[Title] MELSEC-Q series Ethernet interface module lineup   **[Date of Issue]** May, '03
      change and upgraded functions

[Relevant Models] QJ71E71-100, QJ71E71-B5 and QJ71E71-B2

3. Orientation change of the QJ71E71-100 Ethernet interface module connector

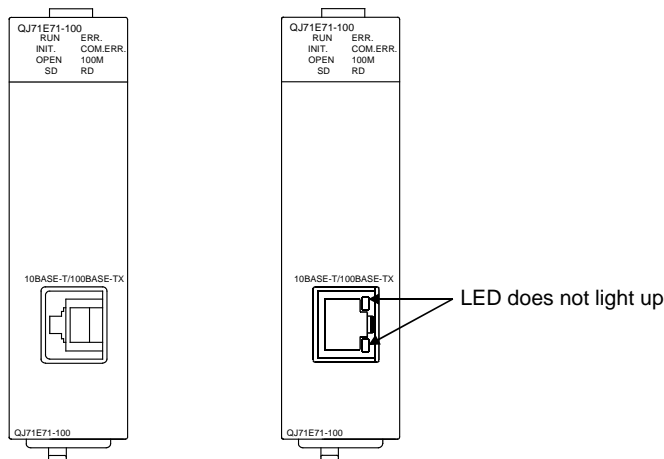
For the QJ71E71-100 Ethernet interface modules with first 5 digits of serial No. 05061 or later, the orientation of the connector has been changed (Rotated by 180 degrees).

Please pay attention to the connector orientation when connecting the network cable.

Also, note that the built-in LED of the connector does not light up.

First 5 digits of serial No.   First 5 digits of serial No.
are 05059 or earlier   are 05061 or later
